# Submissions Report

Rail infrastructure, stations, precincts and operations

**Figure 2-18 Exhibited indicative basement extent – Parramatta metro station (Figure 8-10 of the Environmental Impact Statement)**

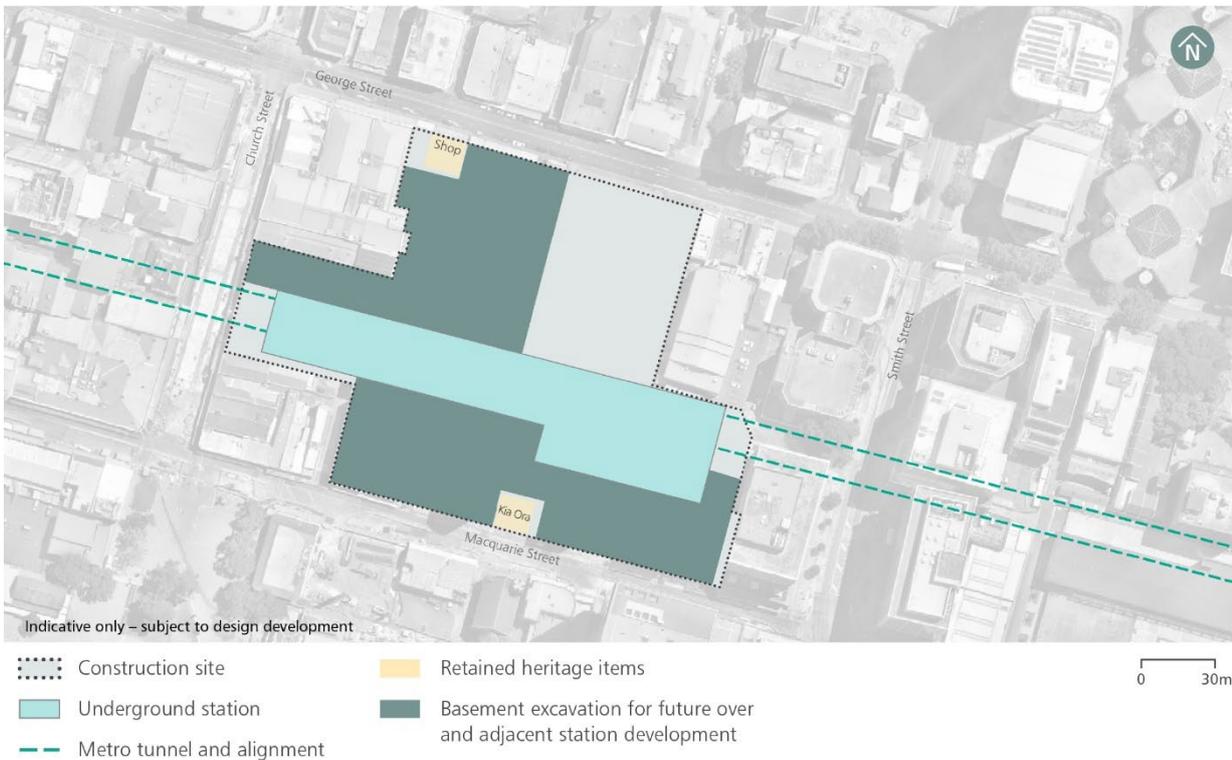
The exhibited indicative construction site layout is shown in Figure 2-16 and the exhibited extent of basement structures is shown in Figure 2-18. The revised construction site layout and extent of basement structures are shown in Figure 2-17 and Figure 2-19.

The extent of basement excavation has also been refined as part of a clarification in this Submissions Report, with Figure 2-19 of this report showing the revised extent of basement excavation at Parramatta metro station.

**Figure 2-22 Revised indicative site layout and key design elements – Sydney Olympic Park metro station**

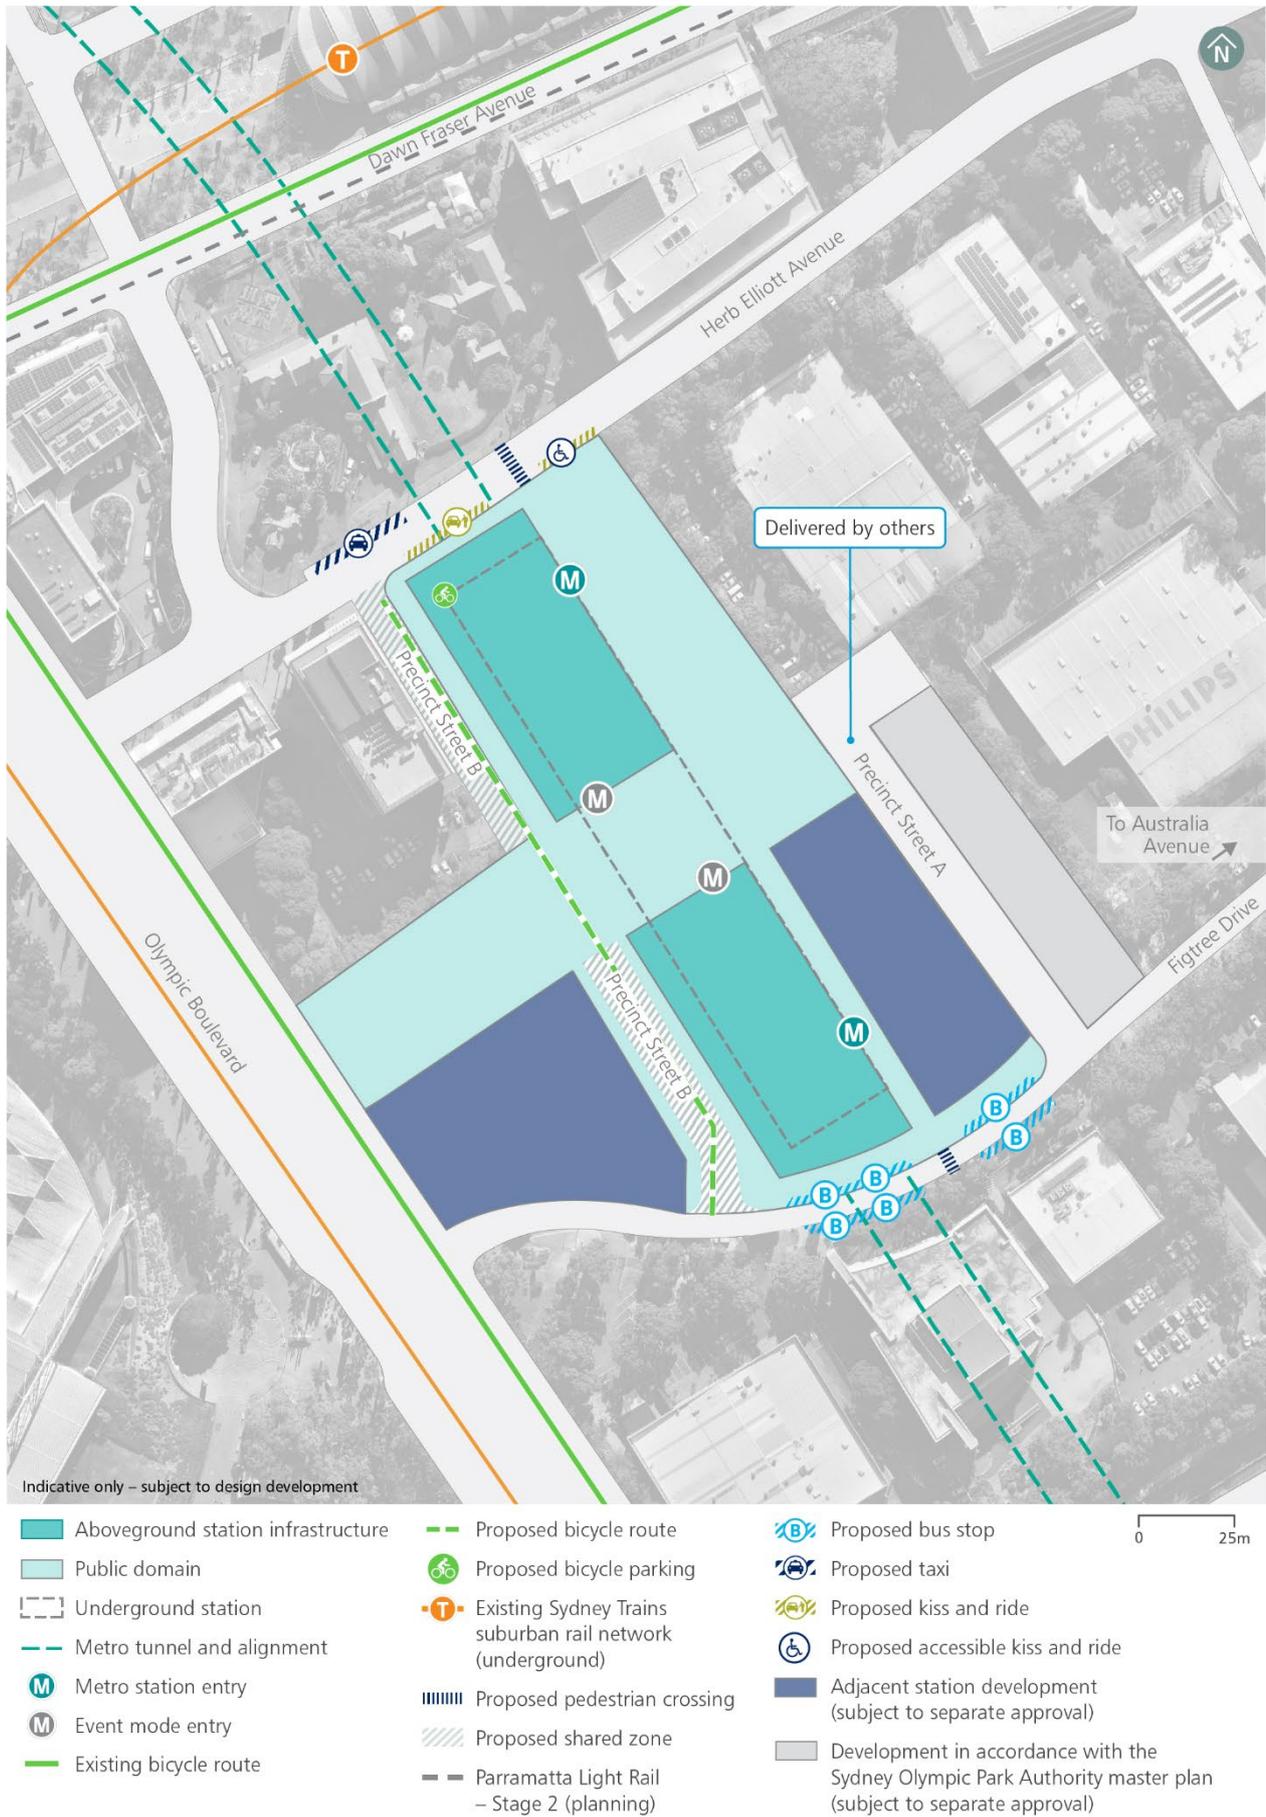
Site 46 is no longer required to form part of the operational station precinct boundary. The exhibited site layout for Sydney Olympic Park metro station is shown in Figure 2-21. Figure 2-22 includes a revised site layout for Sydney Olympic Park metro station which reflects this clarification.

**Figure 2-24 Revised construction haul route - Pyrmont Station construction sites**

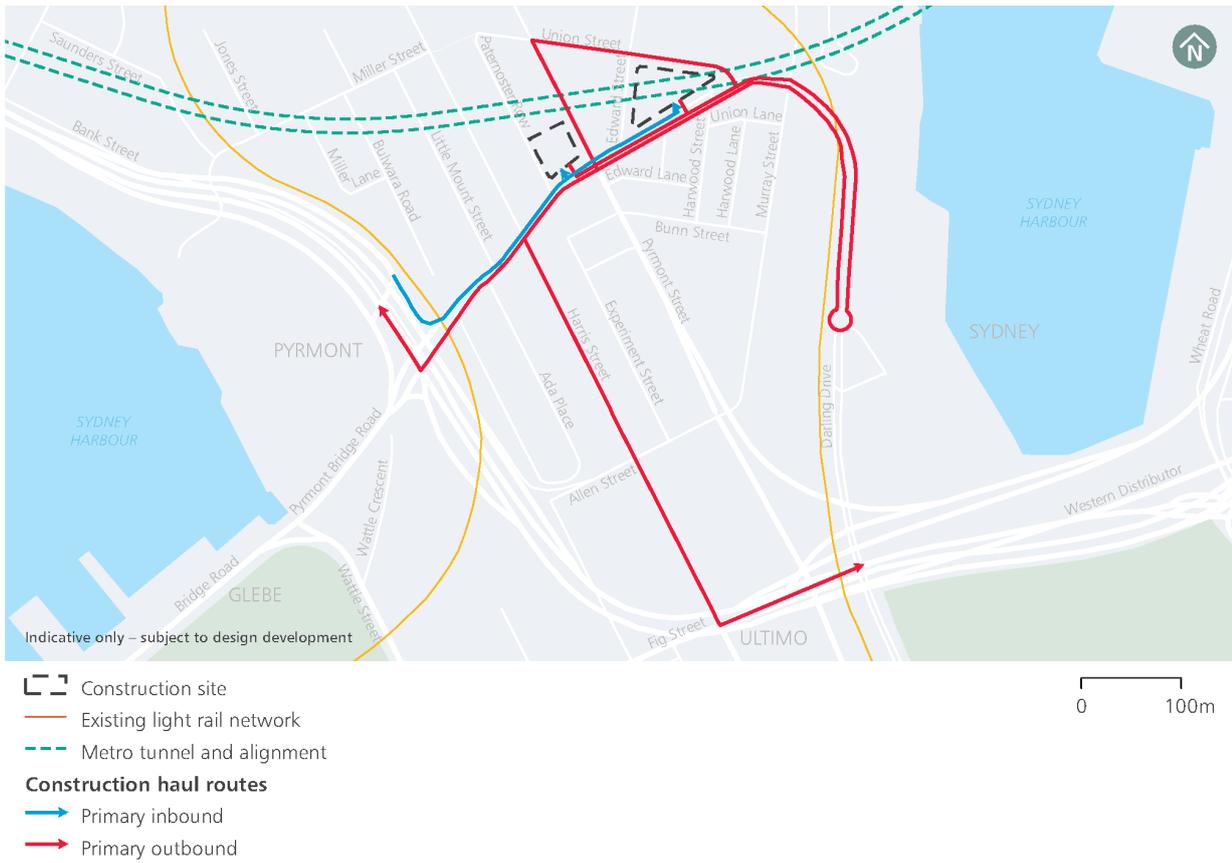
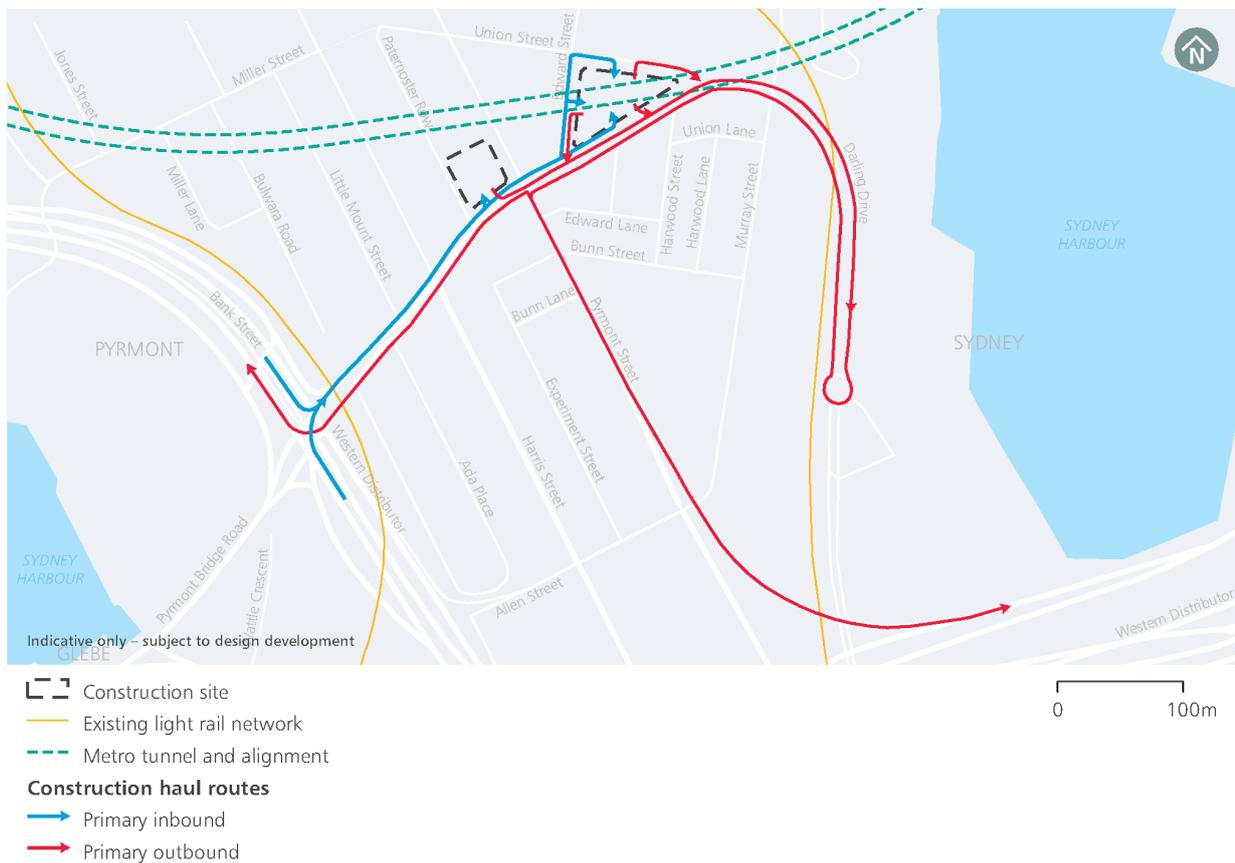
The exhibited construction haul route is shown on Figure 2-23. The refined construction haul route is shown on Figure 2-24 and would involve:

**Figure 2-26 Revised construction haul route – Hunter Street Station (Sydney CBD) construction sites**

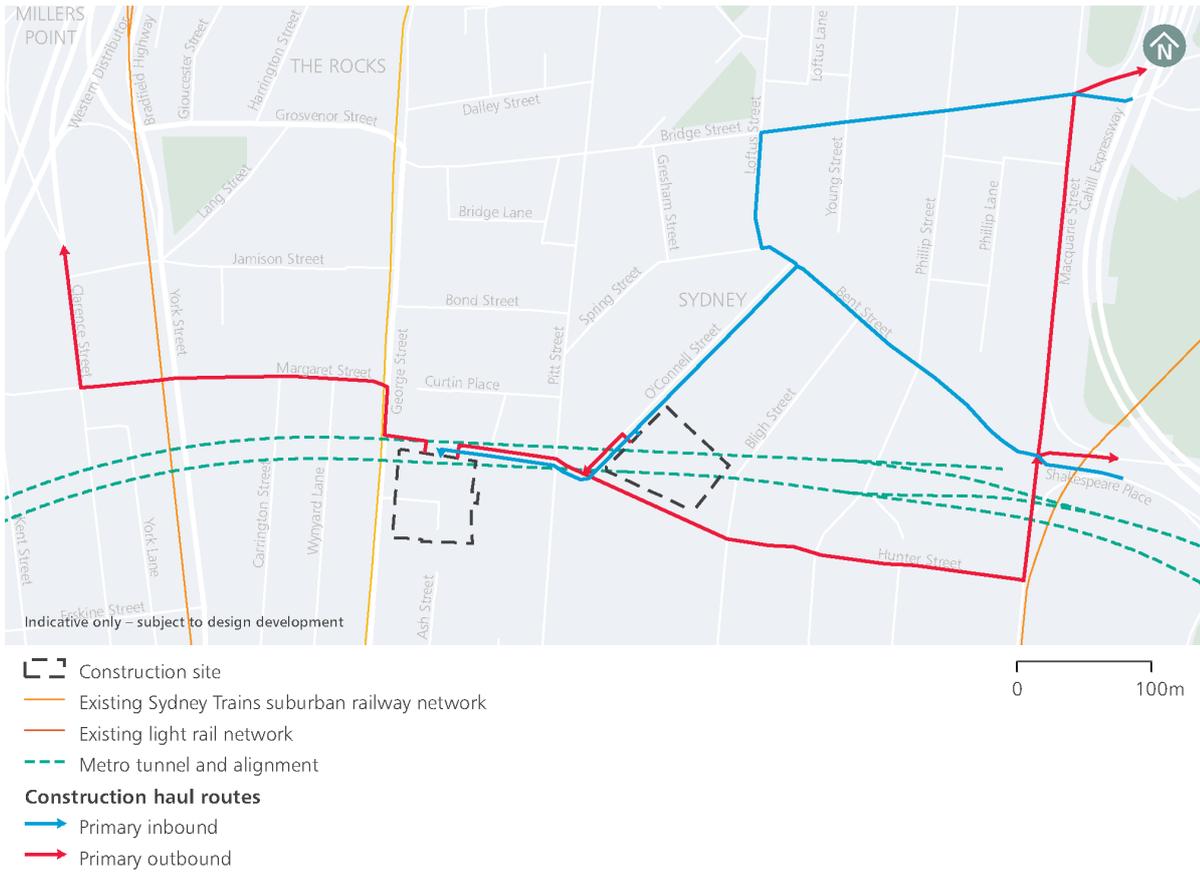
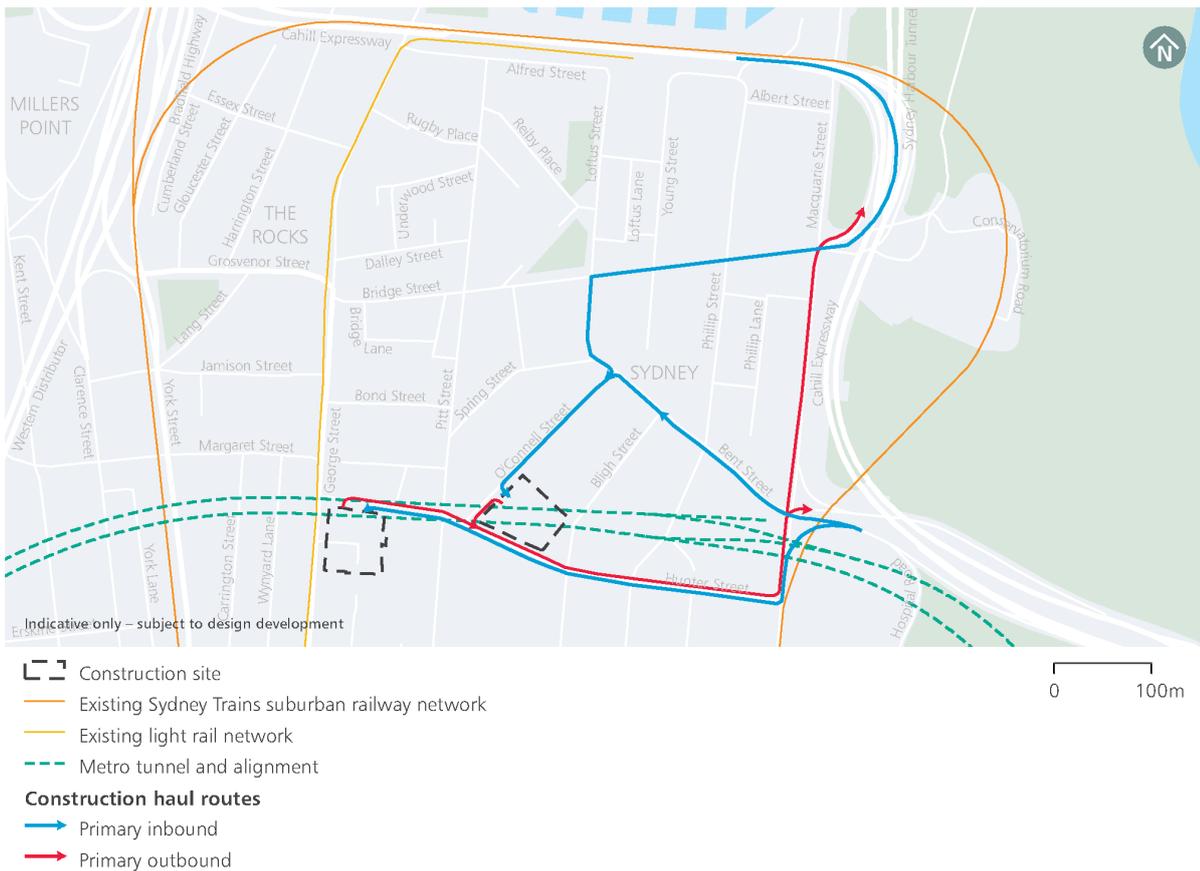
Following consultation with City of Sydney, the outbound haul route from the western construction site via Margaret Street and Clarence Street described in the Environmental Impact Statement is no longer proposed as a primary haul route, in order to improve traffic outcomes. The only outbound haul route from the western construction site would be via Hunter Street and Macquarie Street. This route was assessed in the Environmental Impact Statement.

Potential impacts associated with the heavy vehicle movements using the revised construction haul route are discussed in Section 2.10.2. The exhibited construction haul route is shown on Figure 2-25. The refined construction haul route is shown on Figure 2-26.
